ADDENDUM NO. 1
TO THE CONTRACT DOCUMENTS
for the construction of

Date: August 14, 2014
Project No.: 486753

CHEMICAL SYSTEMS AND ACTUATOR IMPROVEMENTS BID # 913
FAYETTE COUNTY WATER SYSTEM
FAYETTE COUNTY, GEORGIA

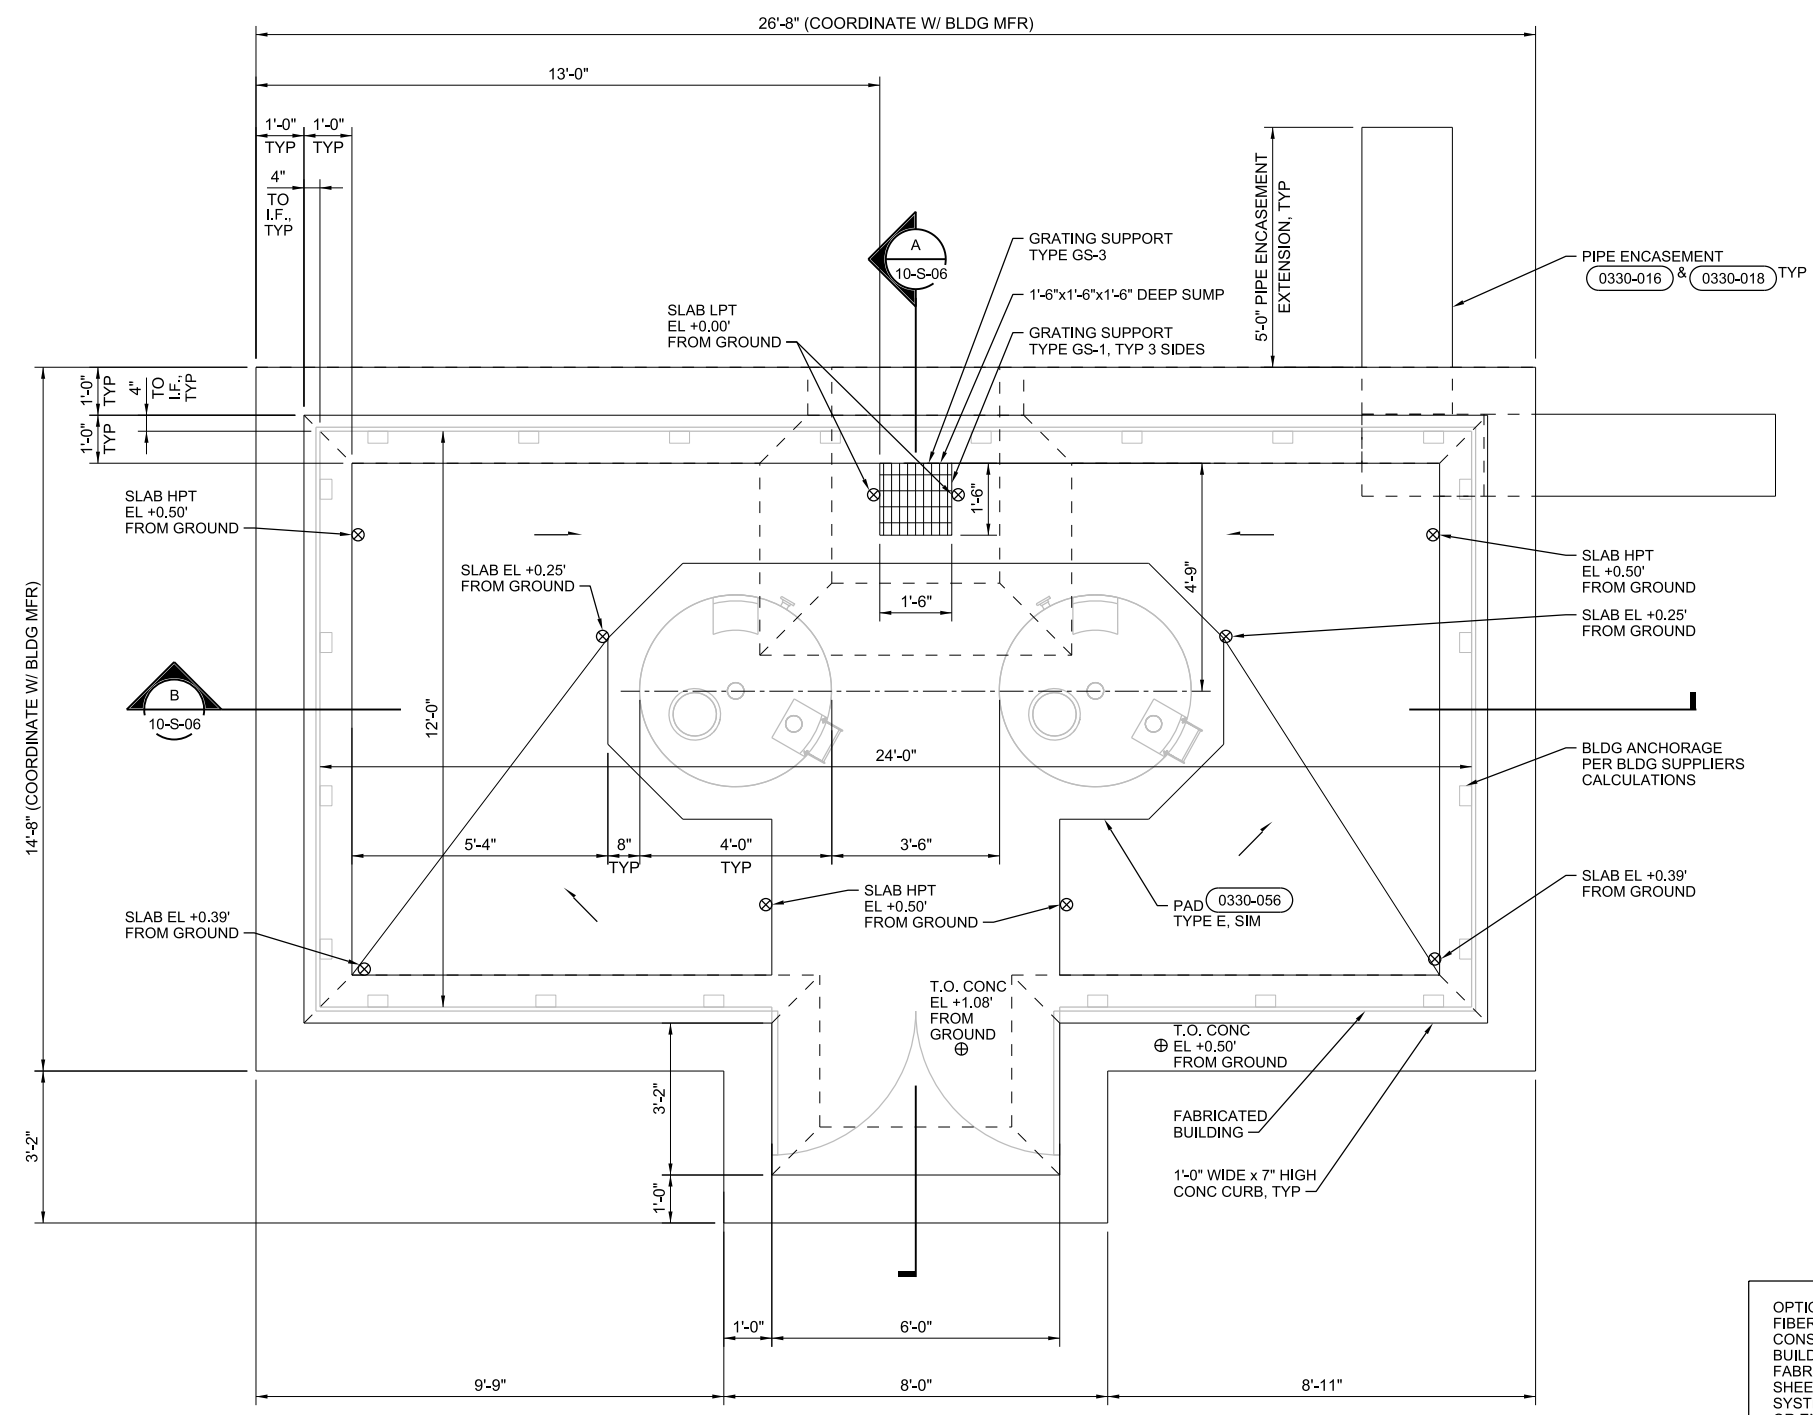
OPTION B IS AN ALTERNATE BUILDING TYPE OF FIBERGLASS CONSTRUCTION THAT SHALL BE CONSIDERED FOR THE FACILITY IN PLACE OF THE BUILDING SYSTEM DESCRIBED IN 13 34 23 FABRICATED STRUCTURES AND SHOWN ON SHEETS 10-SME-02 AND 10-SME-03. THE BUILDING SYSTEM MUST BE THE PRODUCT OF TRACOM, INC OR ENGINEERED APPROVED EQUAL. EQUIPMENT CLEARANCES (AROUND AND BETWEEN TANKS, PUMPS, CONTROLS, AND PLUMBING FIXTURES) MUST BE EQUAL OR GREATER TO THOSE AS SHOWN IN 10-SME-02 AND 10-SME-03. CHANGES TO MECHANICAL DETAILS SUCH AS PIPE SUPPORTS, BUILDING WALL/ROOF PENETRATIONS, PANEL MOUNTING, AND PUMP SUPPORTS AND ANCHORAGE AND BRACING OF THE COMPONENTS ARE THE RESPONSIBILITY OF THE CONTRACTOR AND MUST BE COORDINATED WITH THE ALTERNATE BUILDING MANUFACTURER TO ENSURE COMPATIBILITY.

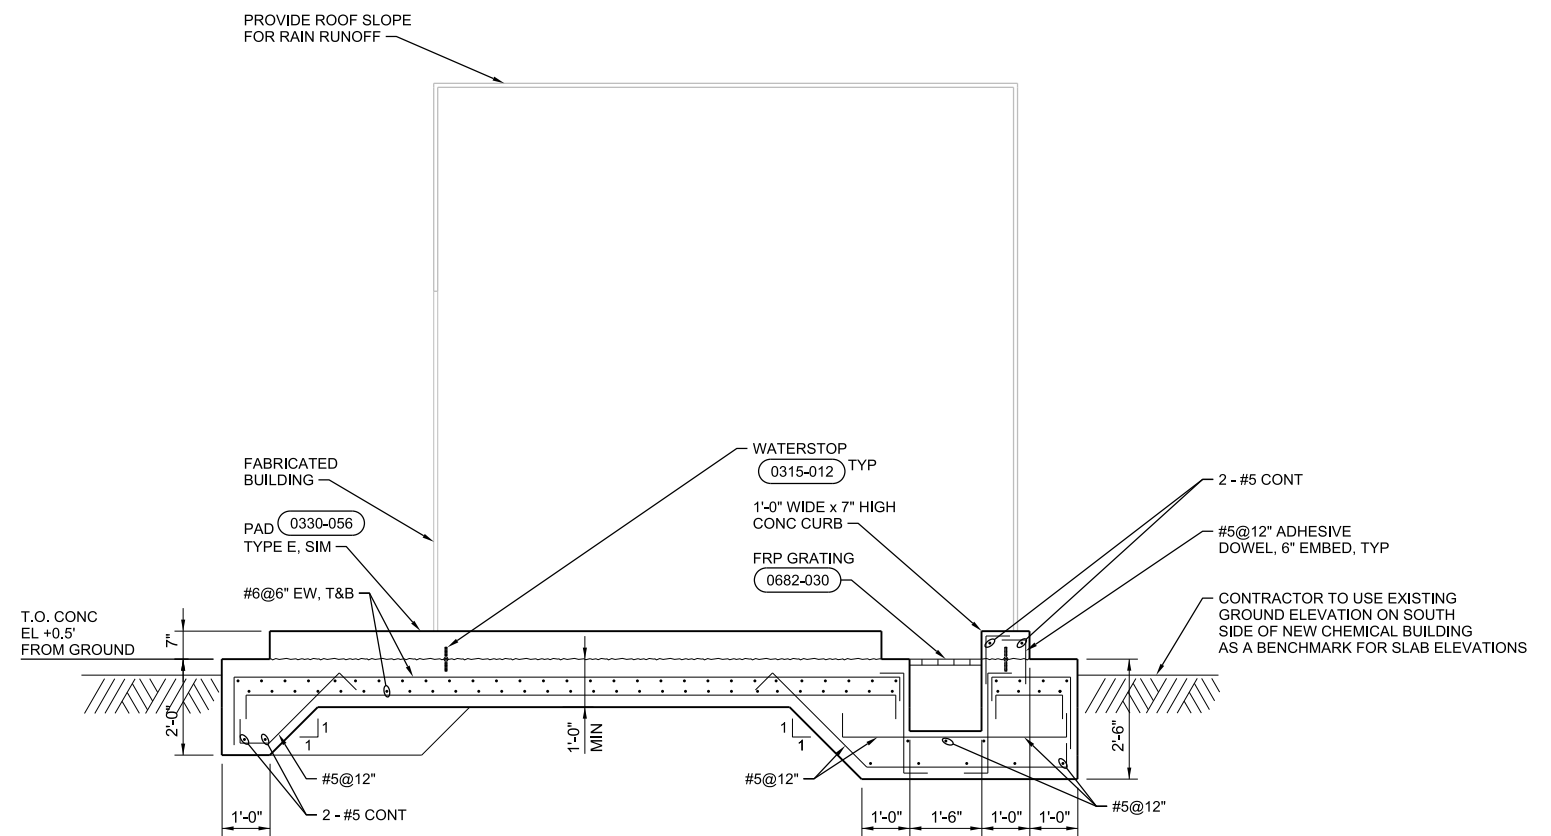
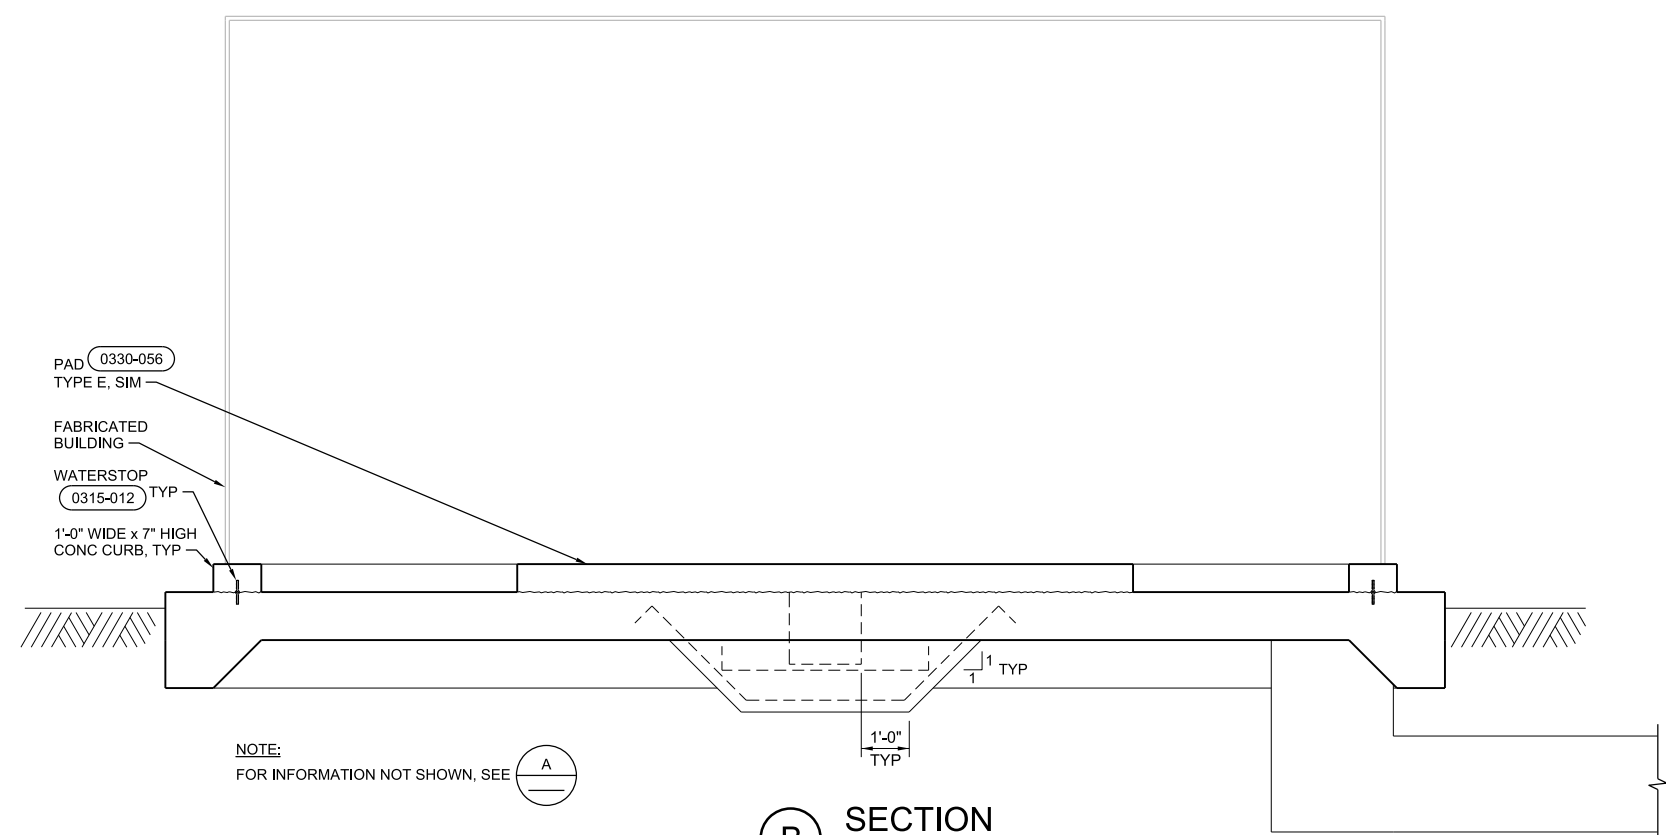
1. Supplement Drawing 10-S-05; DELETE in their entirety and REPLACE with the attached.
2. Supplement Drawing 10-S-06; DELETE in their entirety and REPLACE with the attached.
